**RECLAMATION DISTRICT NO. 1614**

**AGENDA FOR  
SPECIAL BOARD OF TRUSTEES MEETING  
10:00 A.M. JANUARY 18, 2022**

**Staff Report: September 21, 2021, San Joaquin Area Flood Control Agency Permit Application for Smith Canal Gate Project**

Draft conditions as recommended by Consulting Engineer, Ridgeline, are as follows:

SHEET  
C-201  
SHEET 23 OF 139

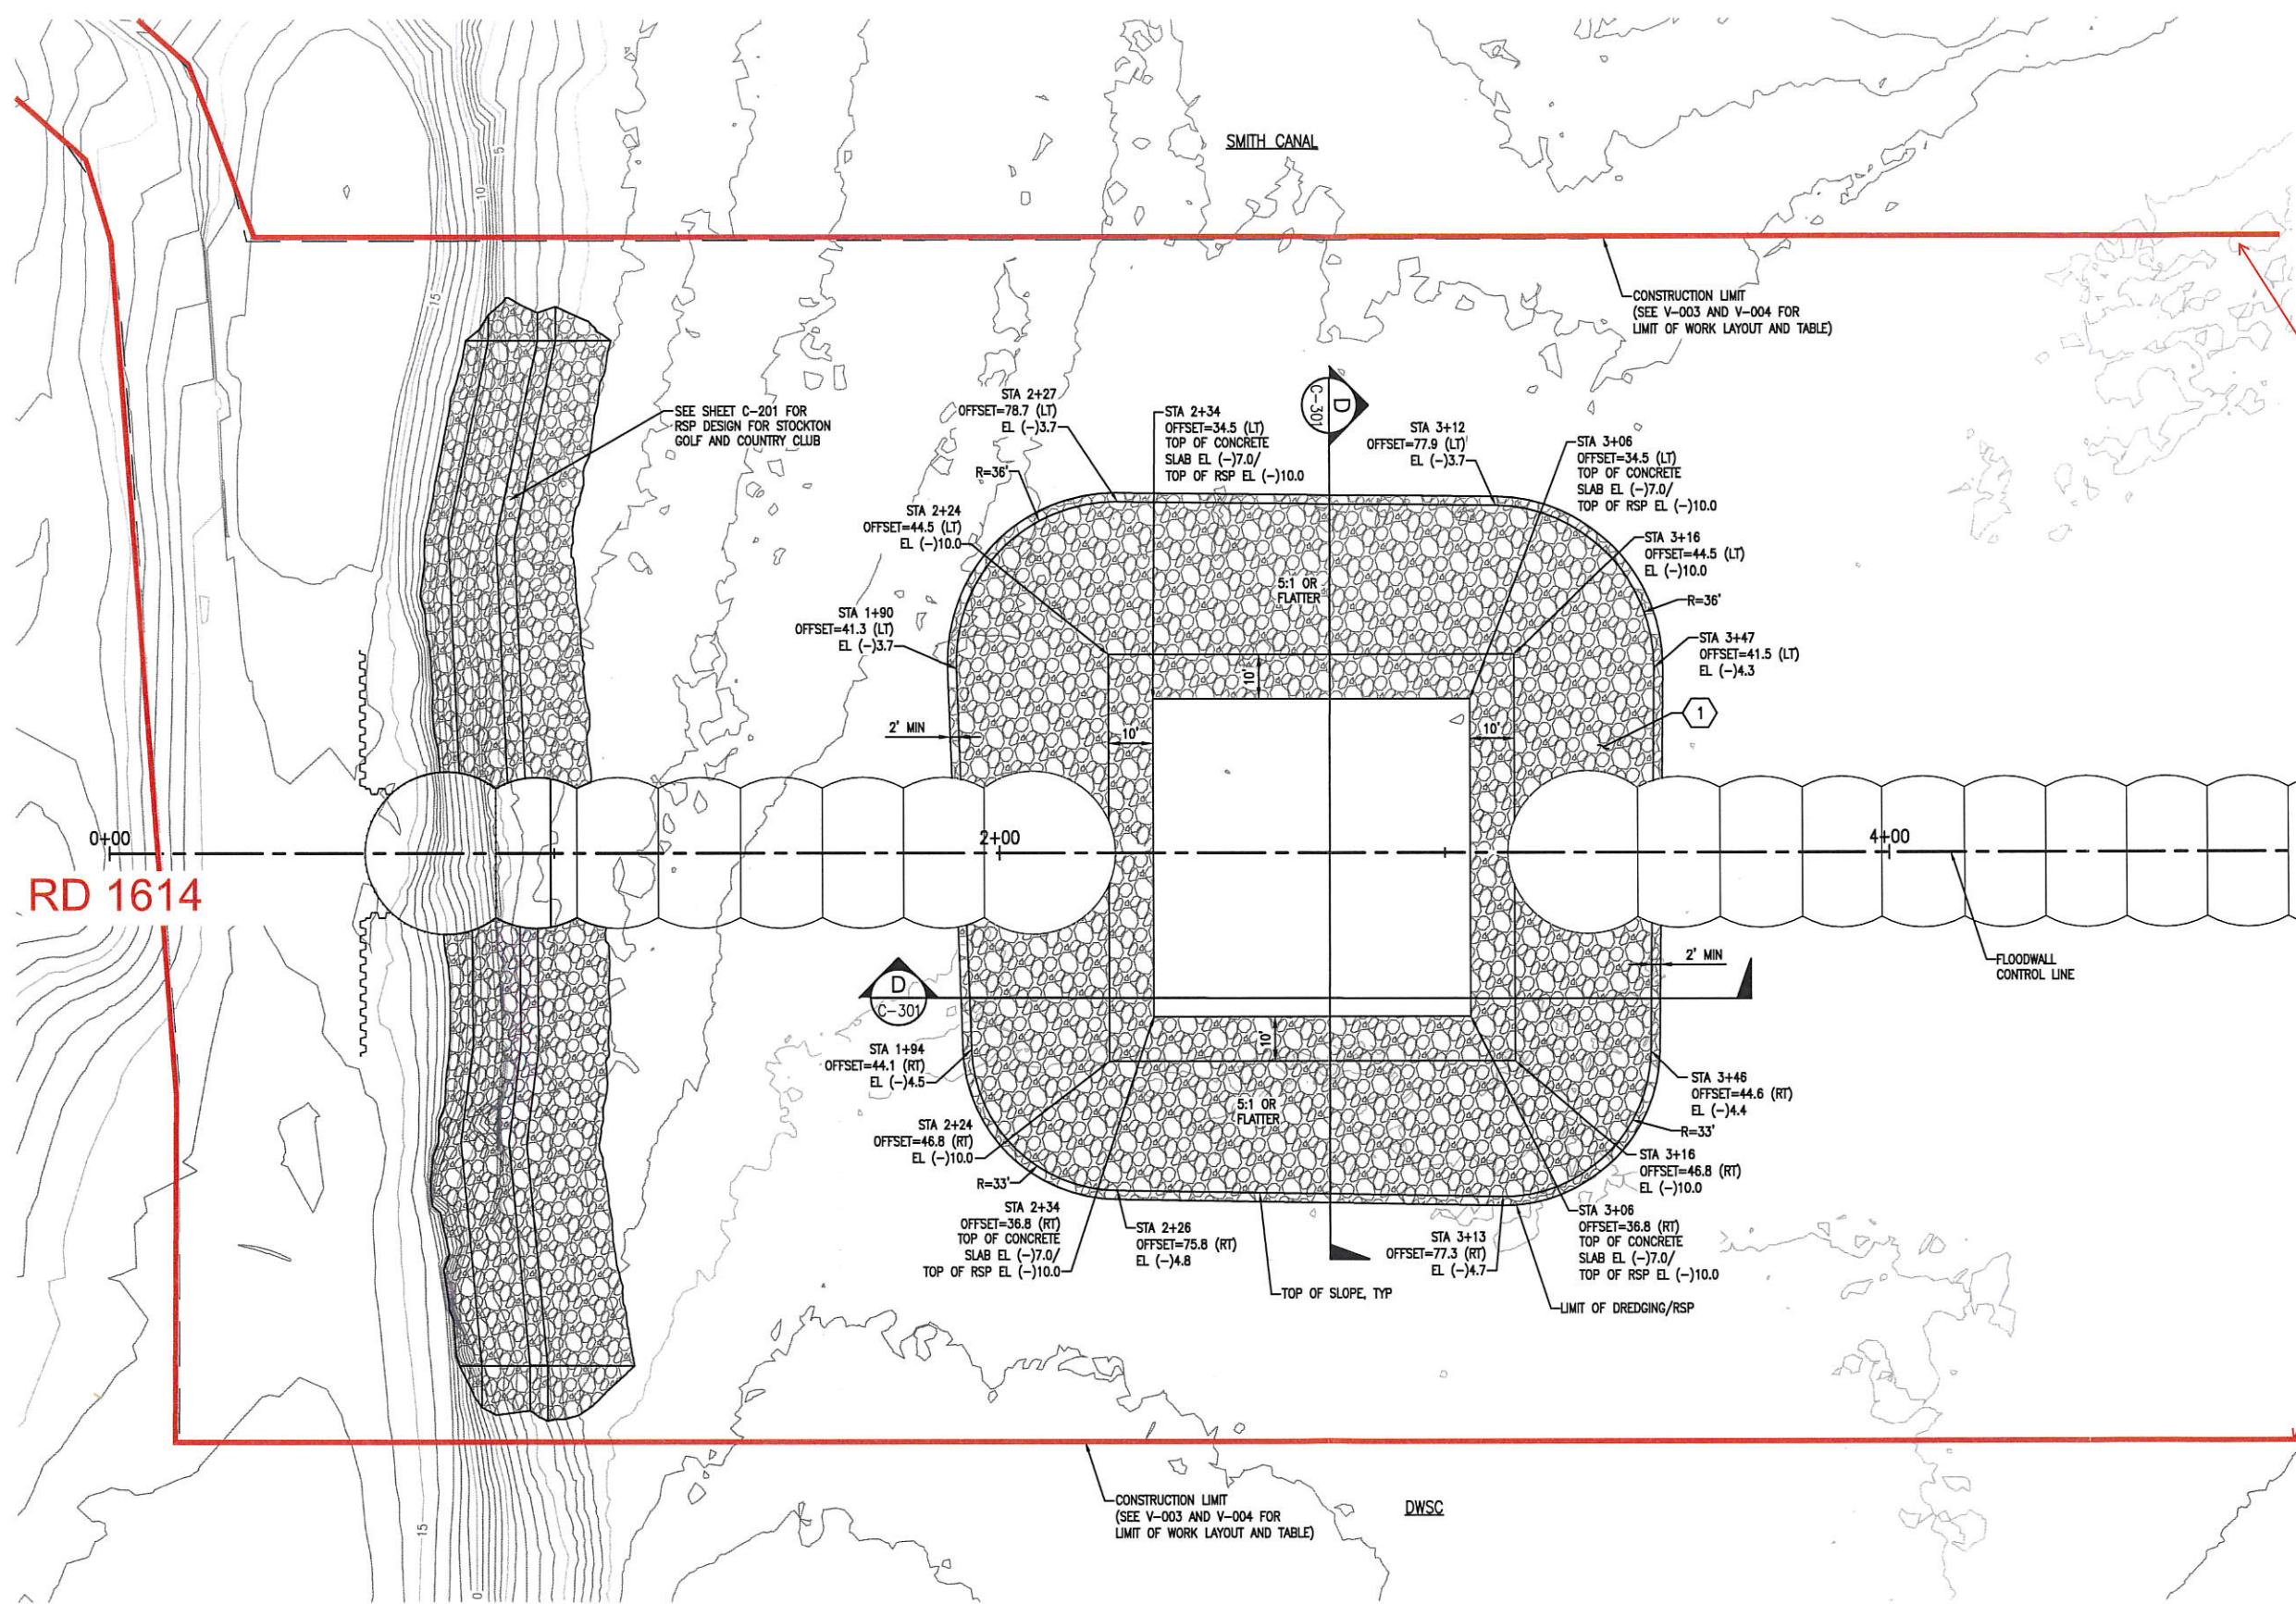
- 1) The plans specify that rock slope protection be installed along the RD 1614 levee 115-feet up and downstream of the dam, per Sheet C-201, and up to elevation 10.4 feet, per Detail C, Sheet C-301. The San Joaquin River Delta Base Flood Elevation Refinement Stage Frequency Analysis report, dated September 2, 2010, estimates the high sea-level rise water surface elevation in excess of 10-feet in elevation in the year 2022, based on a 1/100 annual exceedance probability at a 90% confidence level, per Figure 14. Before a final encroachment permit can be issued, the permittee shall be required to submit to RD1614 the following to the satisfaction of the District Engineer:

- a) A revised stage frequency analysis report indicating current probable flood elevations in conjunction with a wave analysis to support the proposed rock slope protection elevation. Alternatively, an engineering design report may be prepared to justify a revision to the proposed rock slope protection elevation, based on the existing stage frequency analysis in conjunction with a wave analysis or an additional two feet of freeboard.
